**19. OFFICIAL PLAN AMENDMENT FILE OP.18.016 ZONING BY-LAW
AMENDMENT FILE Z.18.028 YONGE & STEELES DEVELOPMENTS
INC. C/O THE GUPTA GROUP VICINITY OF YONGE STREET AND
STEELES AVENUE WEST**

Committee of the Whole Report

**TITLE: OFFICIAL PLAN AMENDMENT FILE OP.18.016
ZONING BY-LAW AMENDMENT FILE Z.18.028
YONGE & STEELES DEVELOPMENTS INC. C/O
THE GUPTA GROUP
VICINITY OF YONGE STREET AND STEELES AVENUE WEST**

VAUGHAN
Yonge Steeles Corridor Secondary Plan
Appendix A
Development Concept

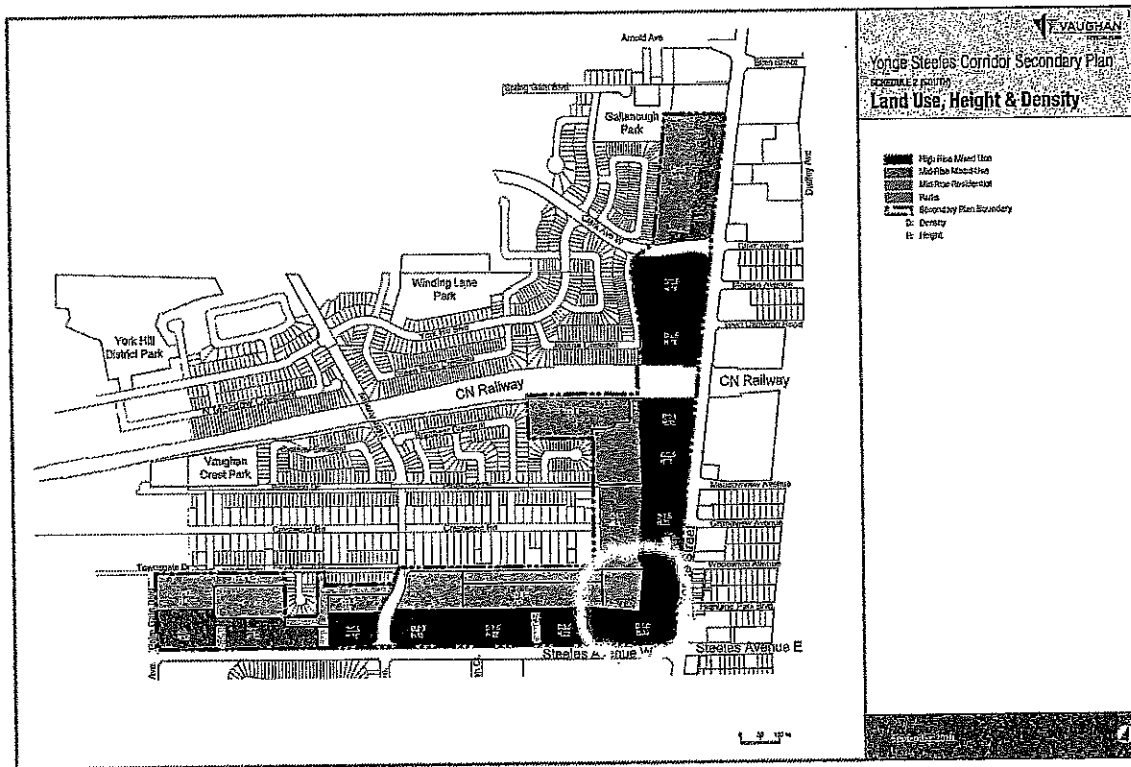
The Yonge-Steeles Secondary Plan calls for lower buildings, up to 30 storeys, at this site and a parkland. The three residential towers are much taller at up to 65 storeys and take away the park. (The landscaped greenery shown in between the three towers cannot be considered a true park). Although the extra property tax revenue from such vertical housing may be attractive to the City, the large additional human-footprint will have considerable impact on the neighborhood.

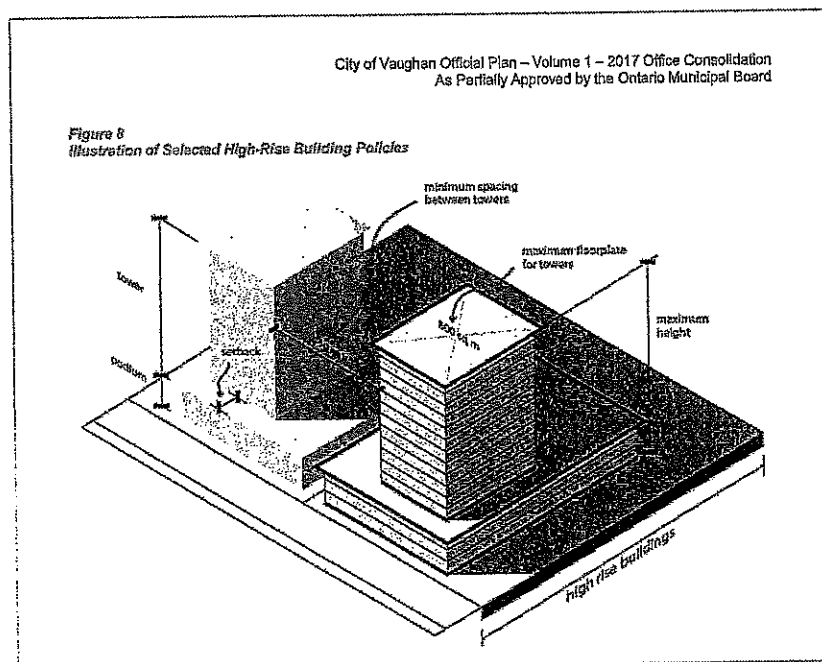
Tower 2 and Tower 3 look to be closer together than the minimum 30m. allowed by Vaughan.

Figure 1: Appendix C (south) – Existing Property Parcels, Proposed Local Streets, Parks & Publicly Accessible Open Space, YSCSP

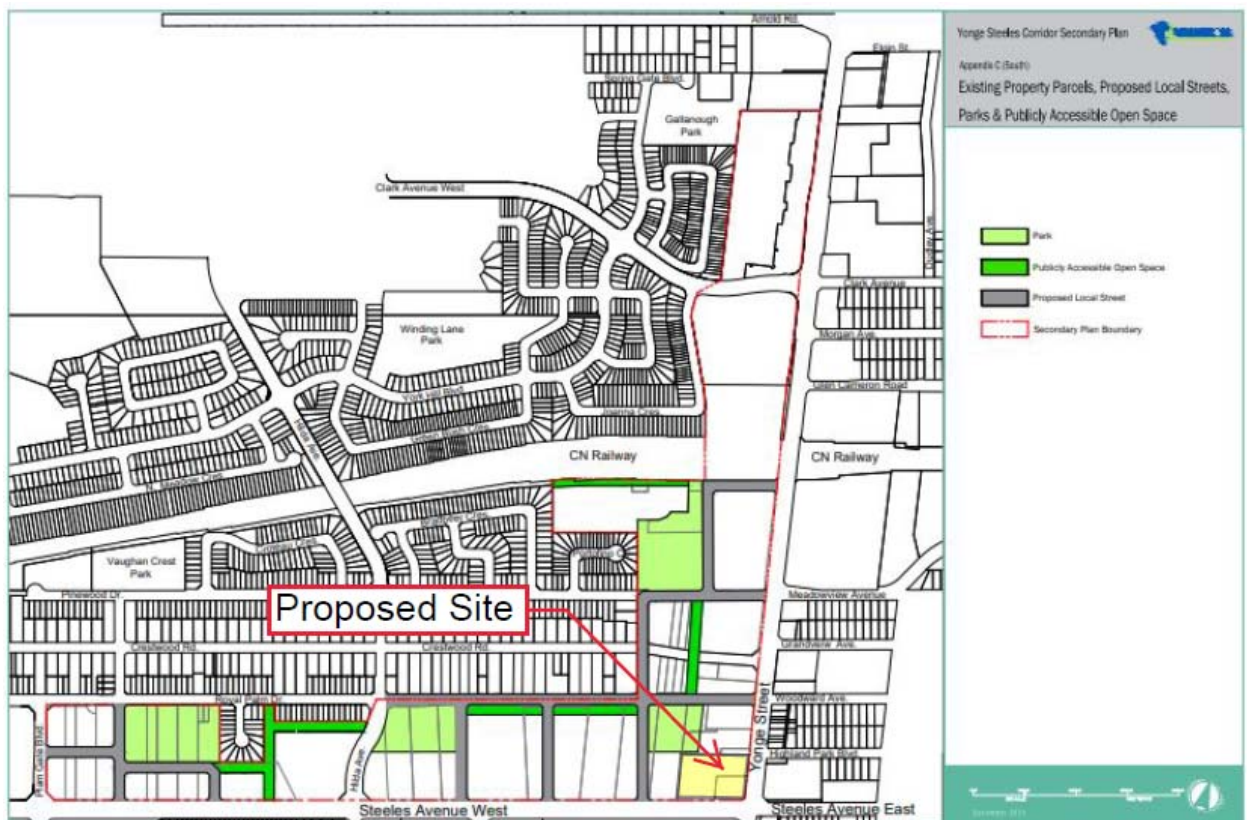
6. A Quadrant Level Study should be conducted, in coordination with adjacent landowners, to provide mutual services, infrastructure and benefits to all properties in the northwest quadrant of Yonge and Steeles intersection. See *Schedule 5 (south) – Proposed Local Streets*, YSCSP or see *Appendix C (south) – Existing Property Parcels, Proposed Local Streets, Parks & Publicly Accessible Open Space*, YSCSP.

The Quadrant Study can evaluate, amongst other needs, a connected, coordinated, porous laneway network providing better interconnectivity within the quadrant and better
